The architecture of LArSoft toolkit (draft)

The LArSoft project

November 30, 2015

Sunday 7:51:39, Ruth Pordes ruth@fnal.gov (“Re: First draft of the architecture description document”)

Figure 2: Components of LArSoft and their interaction with external libraries

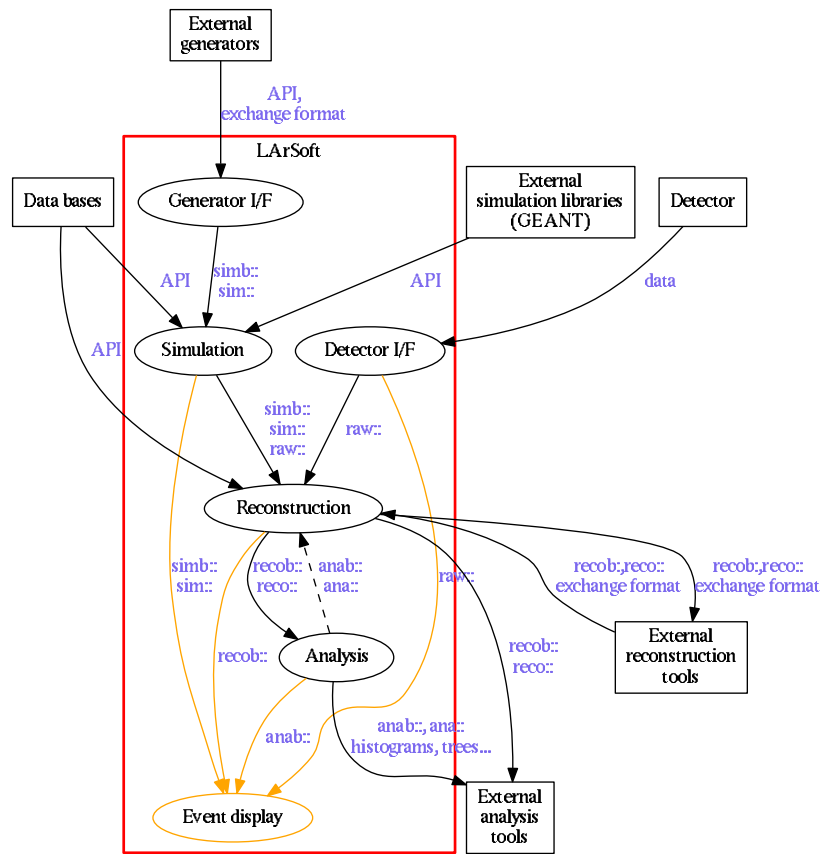
[Q 005] Figure 2. You explicitly mean Detector not DAQ ? Does/shoud daq show up somewhere

[A 005.1] [GP] in practice DAQ products is what we communicate with. It doesn't have to be only that, but I guess that is it effectively what happens. (TODO)

Figure 5: LArSoft algorithm and service model

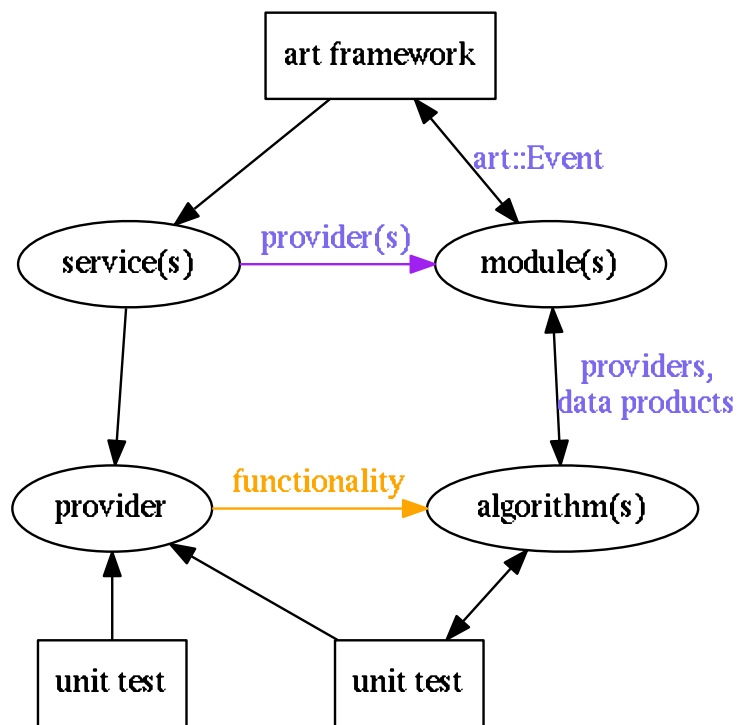
[Q 007] page 10. Unit test. These are important. These are not the only tests. I don't see them referred to and perhaps some more specifics might be useful?

[A 007.1] [GP] I added a section about testing. I have added a few words also at the point Ruth specified (at the end of "User code" section). I think it would be good to add a "test" block in one of the high-level diagrams, but I can't figure out where (probably in 2, but how?). Or maybe we have to add a *development model* section?
